## Brisbane Central Business District Bicycle User Group

Thank you for the opportunity to comment on the June 2016 *Newstead North Draft Renewal Strategy*.

Figure 1

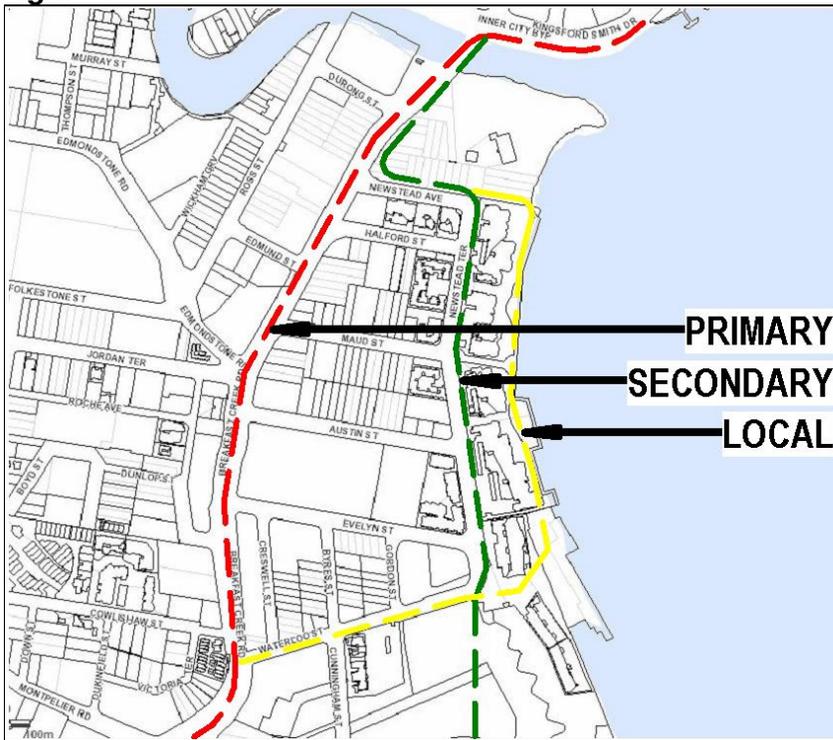
As such the CBD BUG (as part of [Space for Cycling Brisbane](#) coalition) holds that the primary corridor should be Breakfast Creek Road. The secondary corridor should be Newstead Terrace and local corridor should be along the river (see Figure 1). While we understand the selection of corridors was from the City Plan (see Figure 2) we do not agree. It is quite clear the limitations of the existing riverside path are not understood, as it is shown that only "investigations" of upgrading the riverside paths are mentioned in the draft strategy (see Figure 3). The CBD BUG is firmly of the view that both Breakfast Creek Road and Newstead Terrace require upgrading with safe, separated and protected bike lanes.
